## CITY OF FRANKLIN

### REPORT TO THE PLAN COMMISSION

### Special Use

<b>Project Name:</b>	Franklin Mobile Estates Special Use and Land Use Permit
<b>Project Address:</b>	6361 S 27 <sup>th</sup> St.
<b>Applicant:</b>	David Steinberger, Franklin Mobile Home Park
<b>Property Owner:</b>	Franklin Mobile LLC
<b>Current Zoning:</b>	R-8 Multiple-Family Residence District and FW Floodway District
<b>2025 Comprehensive Plan:</b>	Commercial
<b>Use of Surrounding Properties:</b>	R-8 Mobile Home park to the southeast on 27 <sup>th</sup> St. and to the northwest on College Ave.; B-2 General Business District to the northeast on 27 <sup>th</sup> and College; FW Floodway District to the north and south of the swathe of FW on the subject property, and C-1 Conservancy District to the west.
<b>Applicant Action Requested:</b>	Recommendation of approval for the proposed Special Use and associated Land Use Permit for floodway impacts for the construction of a culvert bridge for Franklin Mobile Estates.

CULVERT PLAN & PROFILE

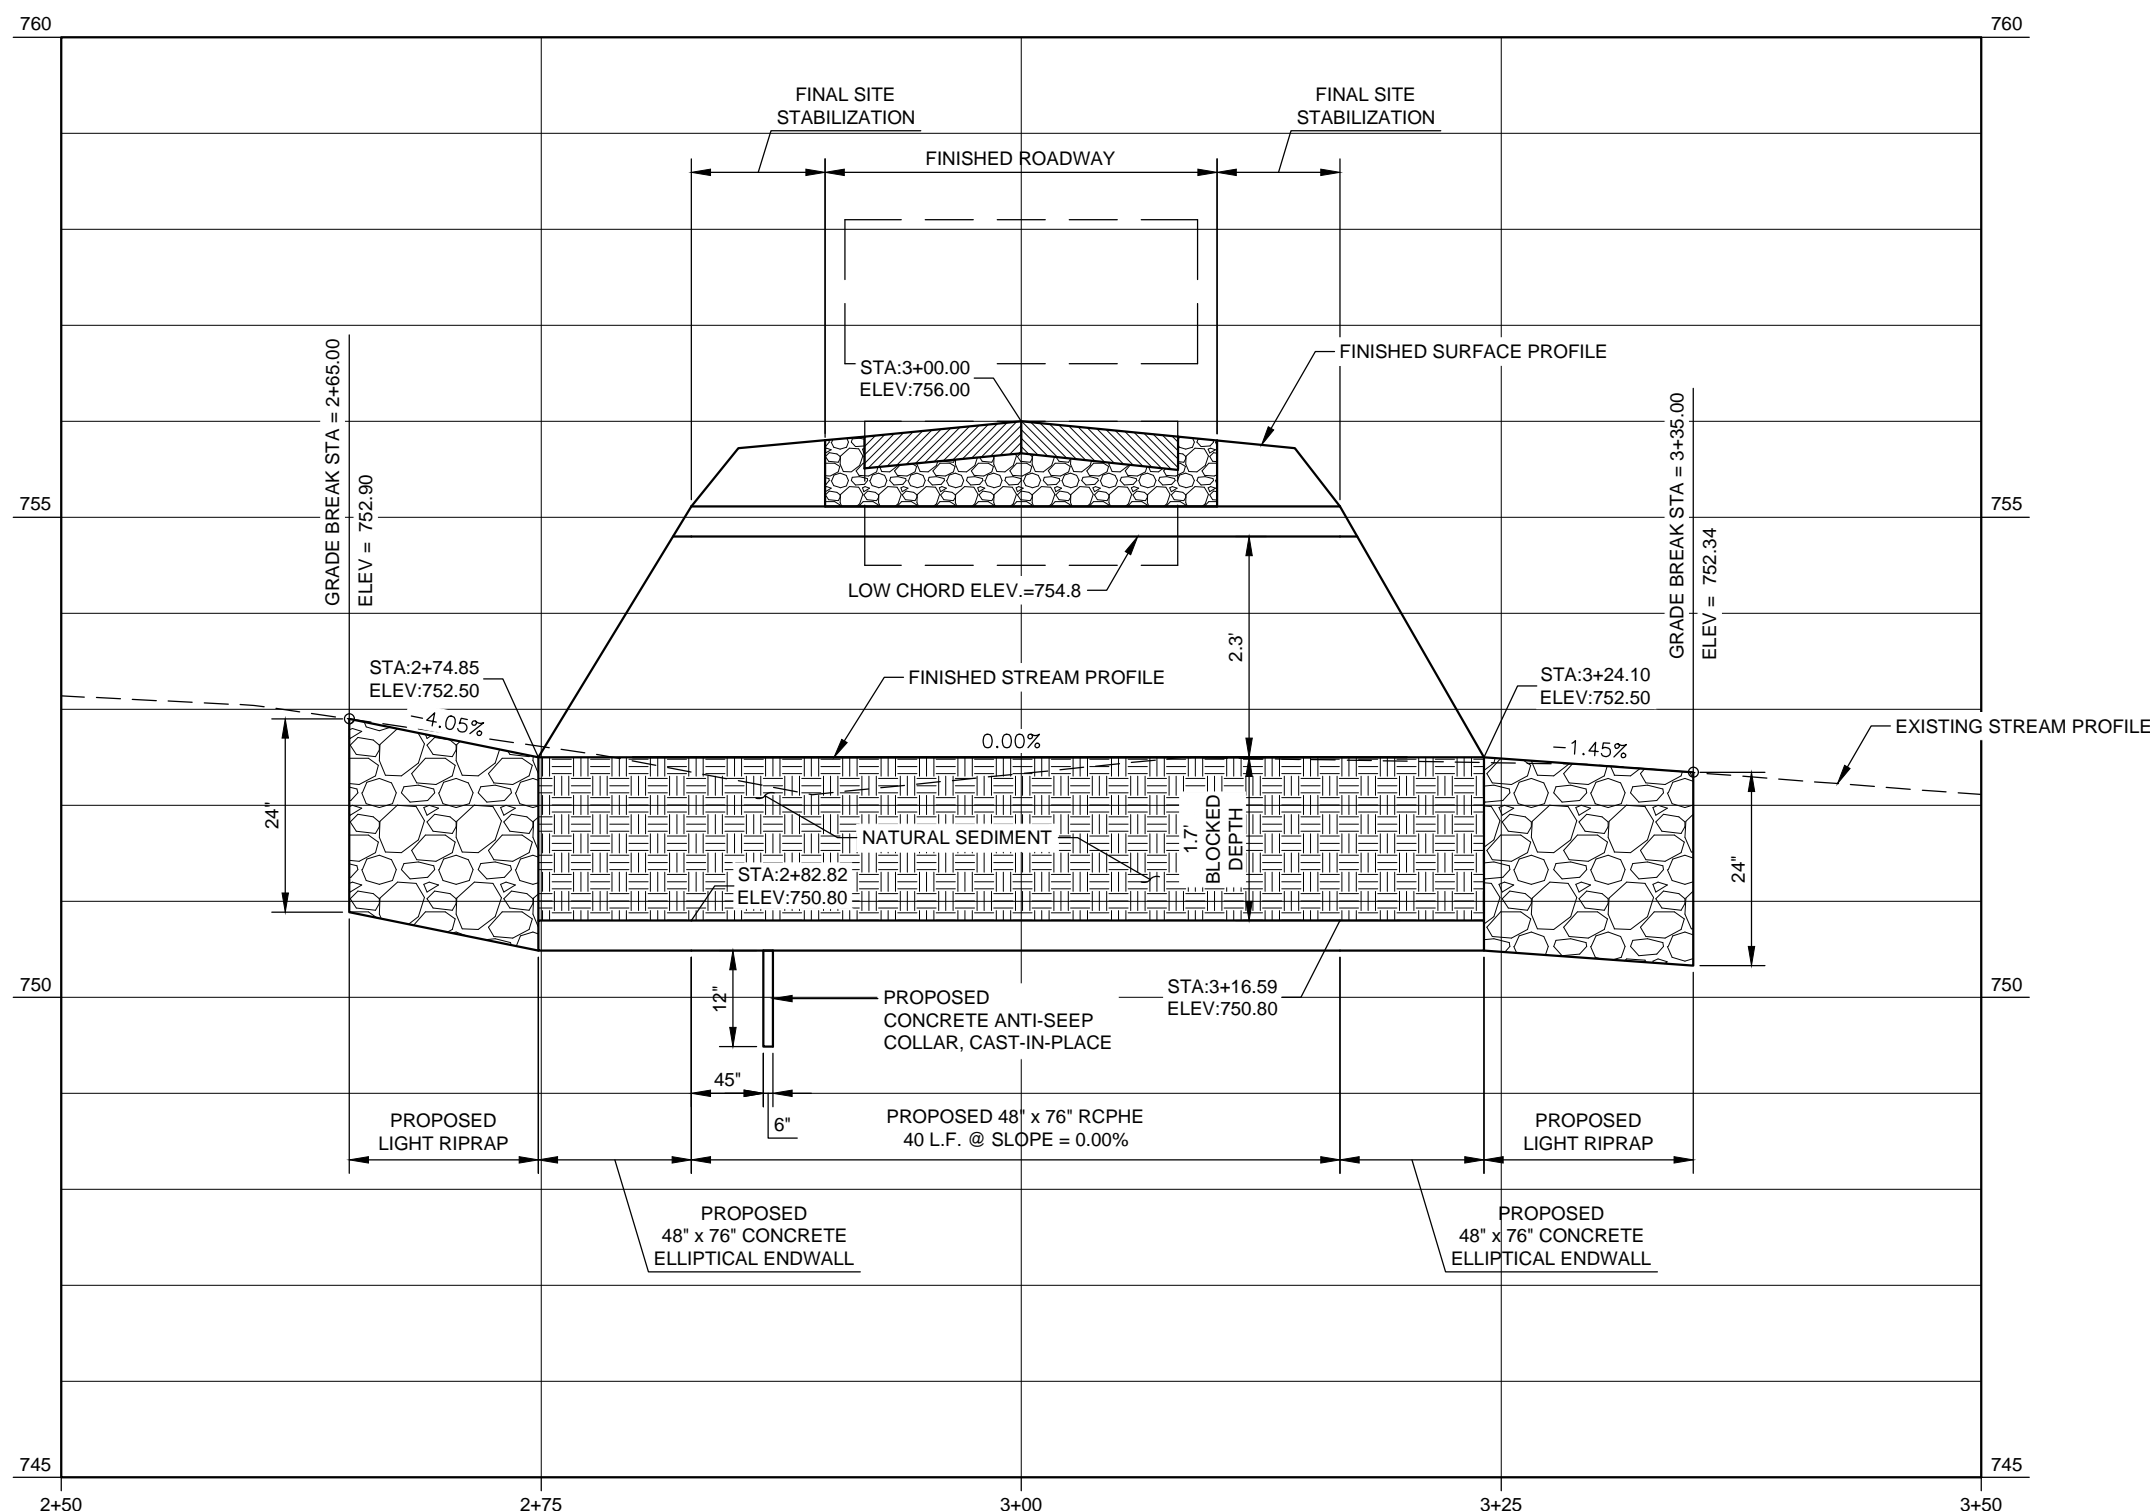
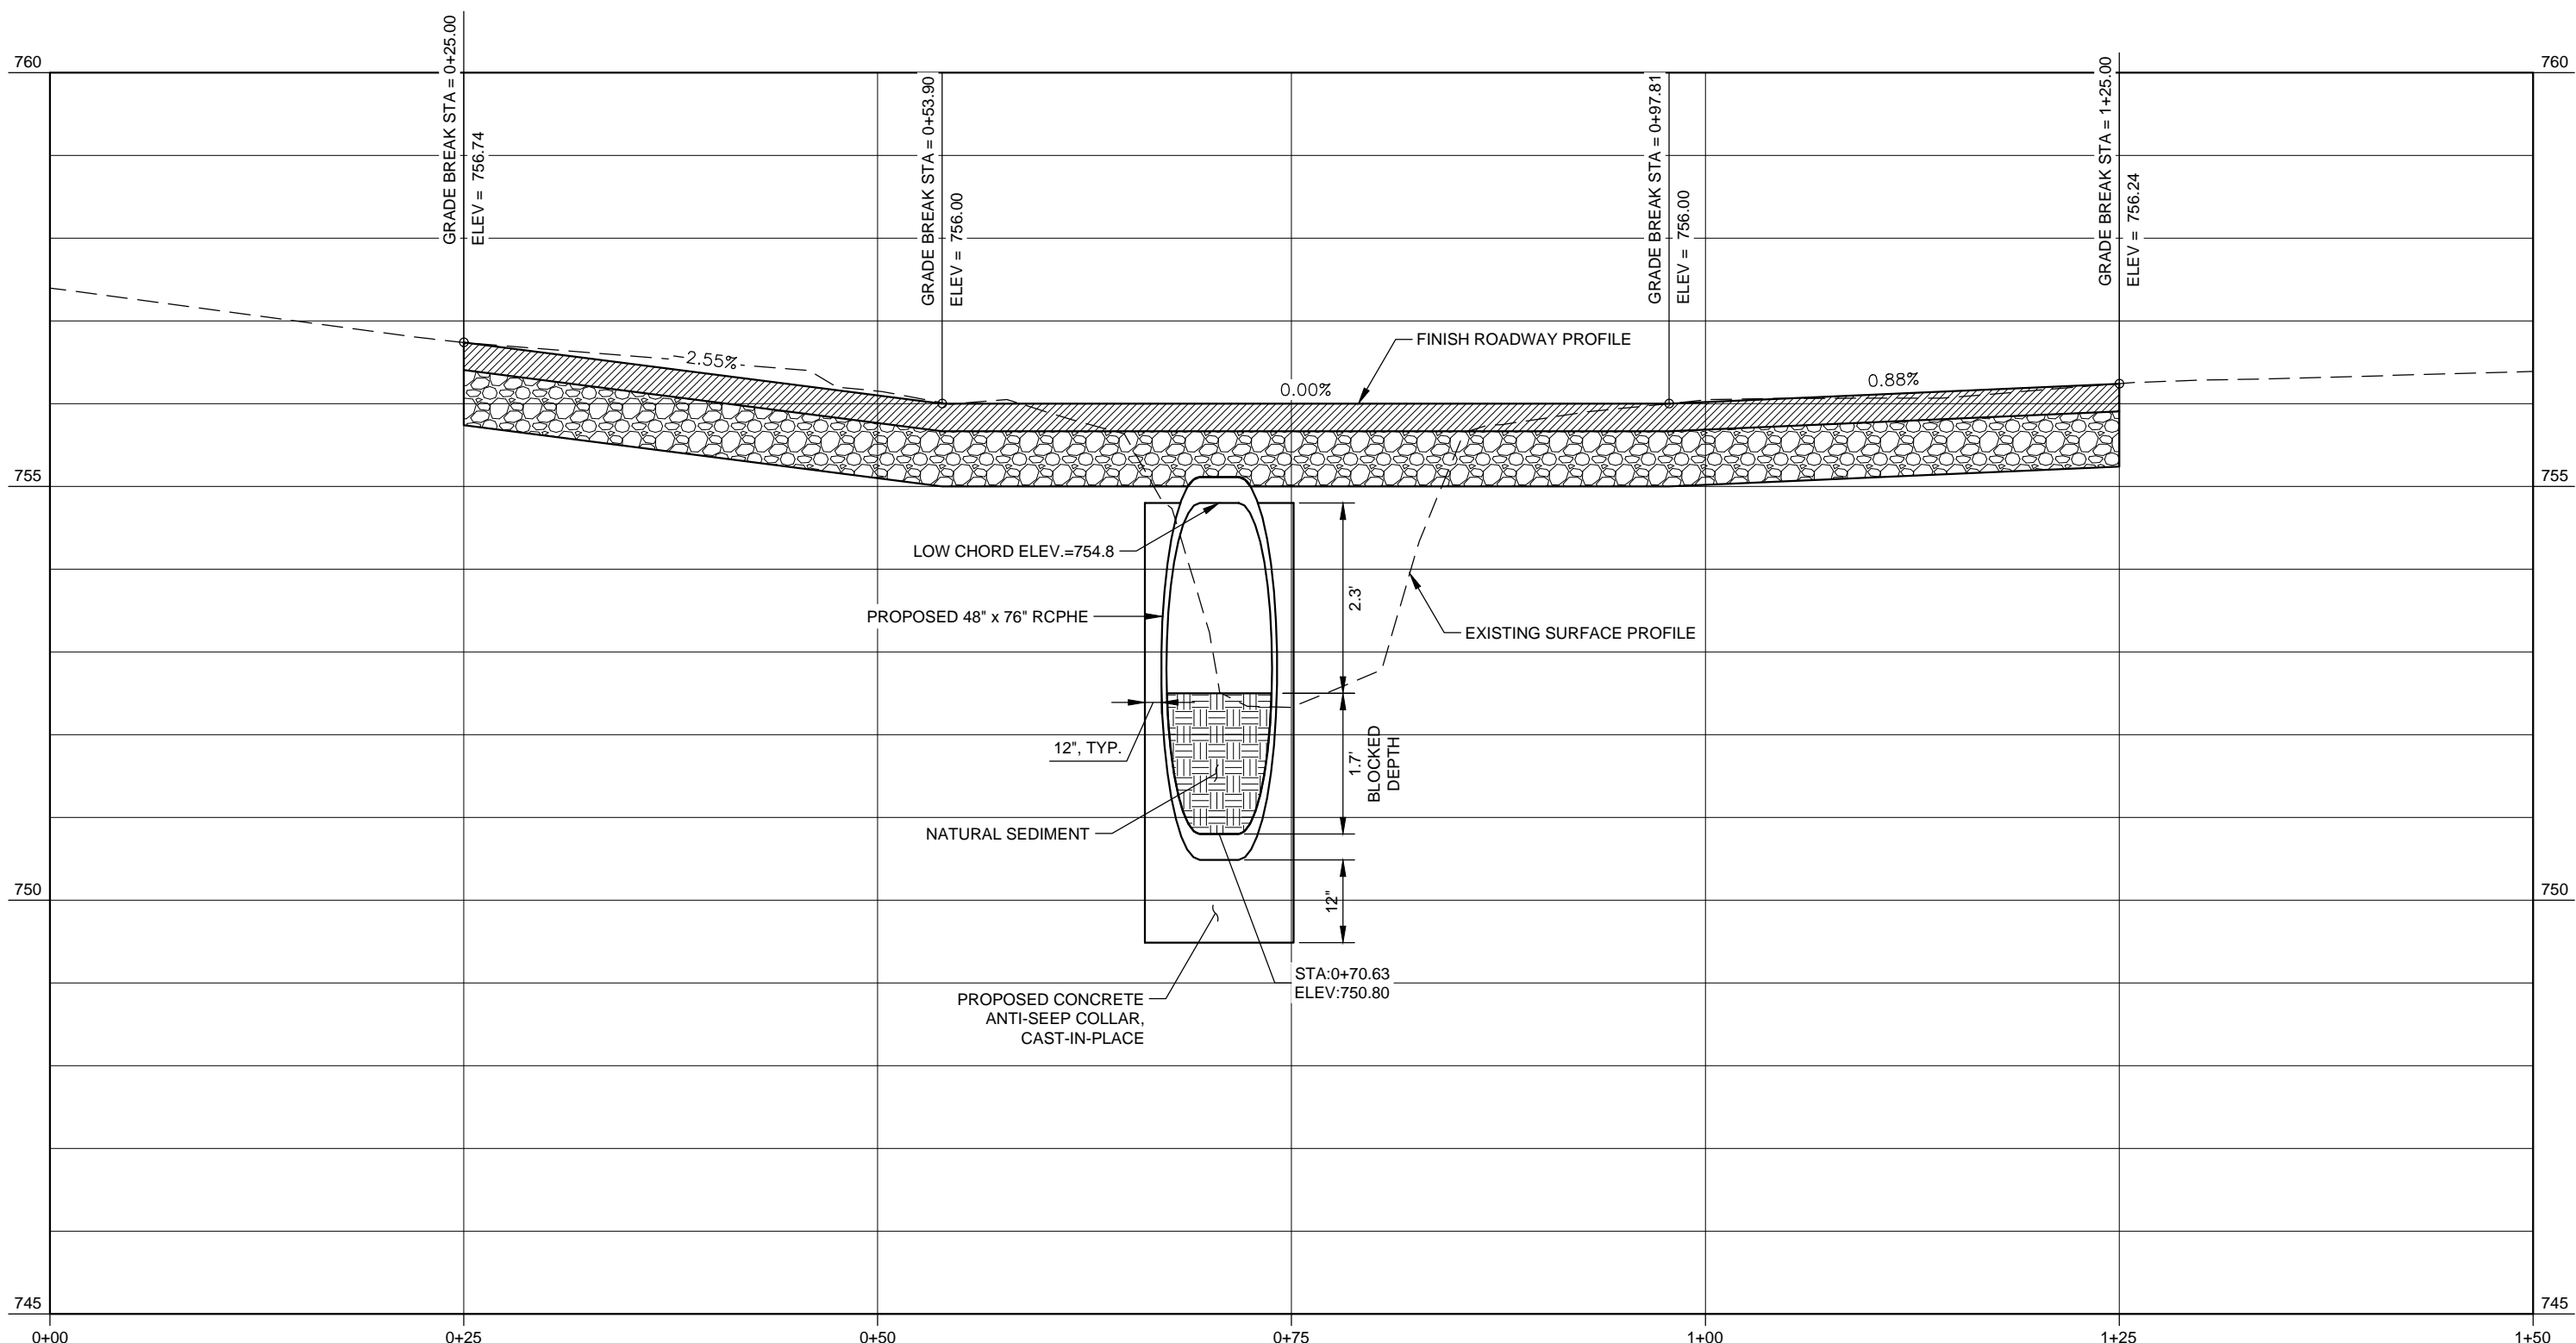
6. The applicant shall revise the site plan to include the addition of railings and paved and striped shoulders along the road over the culvert prior to the issuance of any building permits, and shall install such improvements concurrently with construction of the culvert and road.
